Starwood Power-Midway, LLC Peaking Project (06-AFC-10) Amendment No. 2

Submitted to the California Energy Commission October 2008

Subject: Starwood Power-Midway, LLC Peaking Project Amendment (06-AFC-10), Amendment No. 2
URS Project No. 27656131.00700

APPROVED GAS METER AND PIPELINE LOCATION
STARWOOD POWER PROJECT AMENDMENT NO. 2

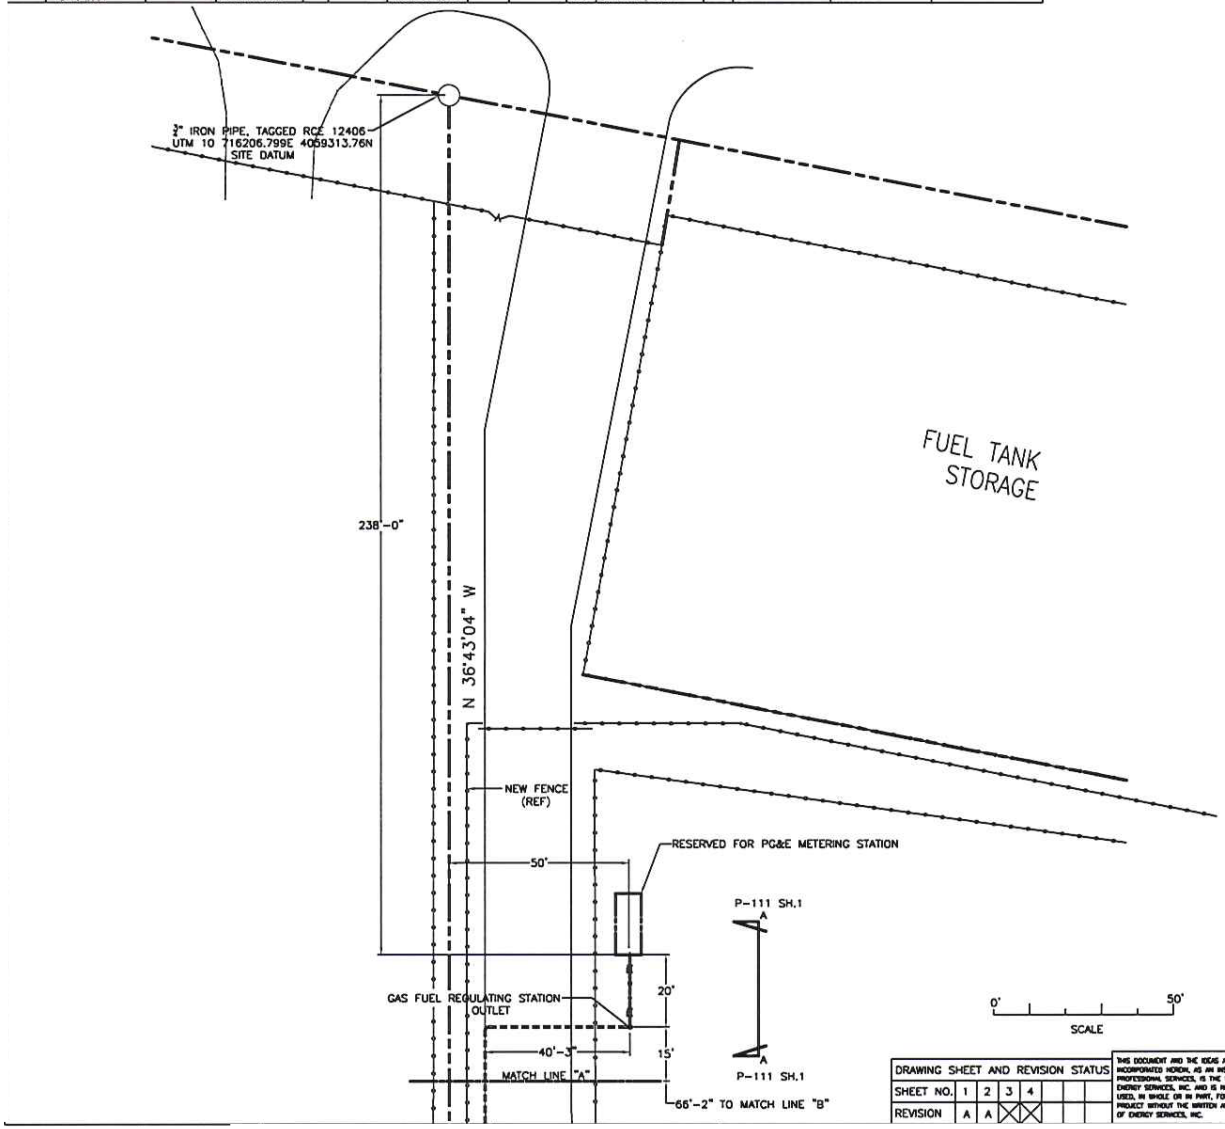
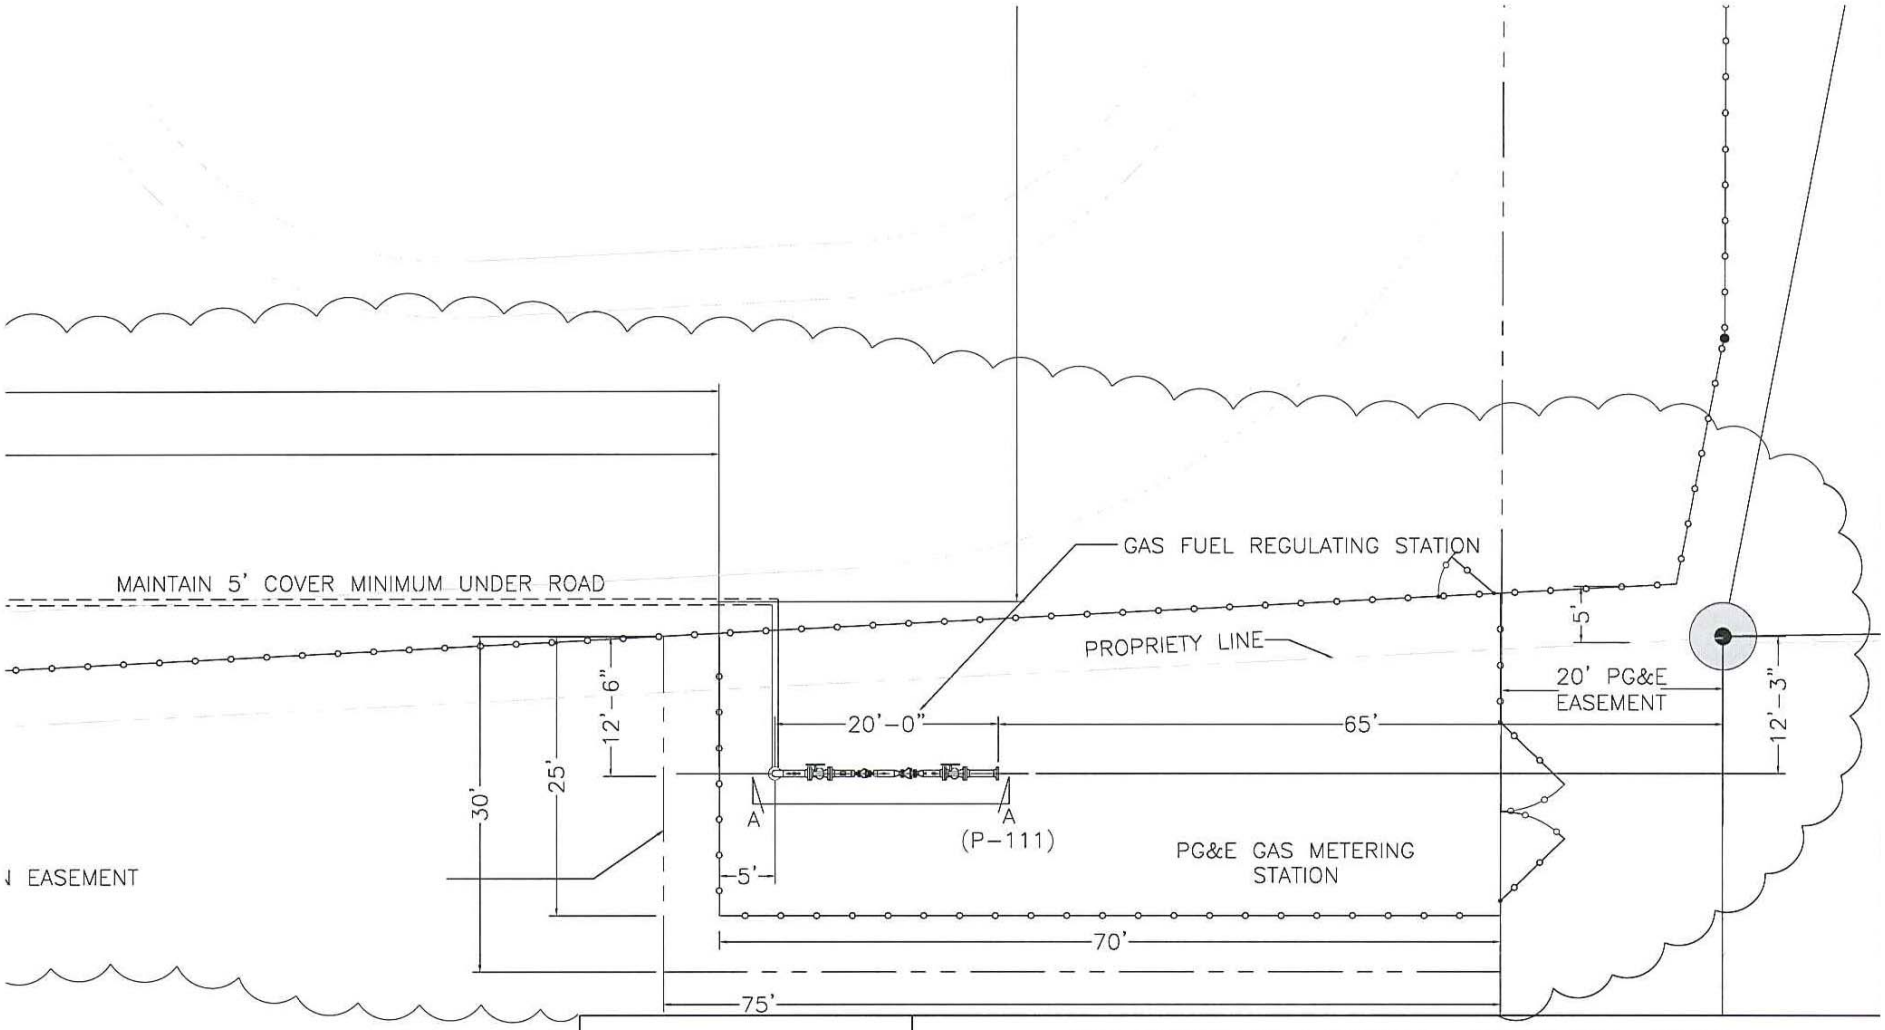
Starwood Power-Midway, LLC is proposing an incremental change to the Midway 2006 AFC that includes relocation of the approved gas line route, meter set, and pressure regulators. The new route for the gas pipeline will change to reflect the new location of the PG&E supply and meters; however it will remain completely on the Midway property. The approved on-site 6-inch gas pipeline is approximately 540-feet in length and extends from the on-site meter set located at the western boundary of the Project site, north to tie into the PG&E Backbone Transmission Line running along (parallel to) West Panoche Road at the northwest border of the Project site. The revised gas pipeline is proposed as a 4-inch pipe, would extend for 600-feet, and tie into the PG&E Backbone Transmission line running perpendicular to West Panoche Road and along the northeast border of the Project site.

In addition, the meter set and pressure regulators will be relocated from the approved location at the western boundary of the Project site, to an off-site leased fenced 25 X 75-foot area located just outside the southeastern corner of the Project site. This will allow for Project connection to the back bone PG&E main Backbone Transmission line which runs through the PG&E Pipeline Right Of Way (ROW). All proposed incremental changes to the Midway Project are further described in Section 2.0, Project Description.

The proposed incremental change to the Midway Project includes relocation of the approved gas pipeline route and connection point to a back bone transmission line which runs through the PG&E Pipeline Right Of Way (ROW) that is on the east side of the Midway Project site. By utilizing this alternative, PG&E will only need to install approximately 60 feet of pipe to reach the PG&E meter run and all of the pipe up to the meter run will be inside the existing PG&E gas line ROW. Starwood is now required to provide a fenced area for the new 25 X 75-foot meter run, which is not within the existing PG&E gas line ROW. The Midway site is fully utilized and grading plans and surface designs have been completed, reviewed, and construction is currently underway. The Petitioner's plan to provide this additional 25 X 75-foot area for the meter run is with an easement of additional land just outside and parallel to the Project site. The Petitioner has negotiated with the Project's landlord to provide an easement, which is contiguous to the southern Midway property line, approximately 25 feet wide and 75 feet long. The easement is located on a land locked property which is triangular in shape at 200 X 200 X 100 feet, and is surrounded by the Midway site leasehold, the Wellhead Power plant and the PG&E gas line ROW. The southernmost border of the easement will be the Midway property line and will extend from the Midway property 25 feet south and continue in an east west direction for 75 feet.

The route for the gas pipeline on the Project site will change to reflect the new location of the PG&E supply and meters; however it will remain completely on the Midway property. The approved on-site gas pipeline was approximately 540-feet in length. The new pipeline length is 600-feet. This is considered a minor change. Also the pressure regulators downstream of the meter run, which are required to regulate gas pressure to the gas turbines, be will moved off the Project site and onto the new easement.

PROPOSED GAS METER AND PIPELINE LOCATION
STARWOOD POWER PROJECT AMENDMENT NO. 2
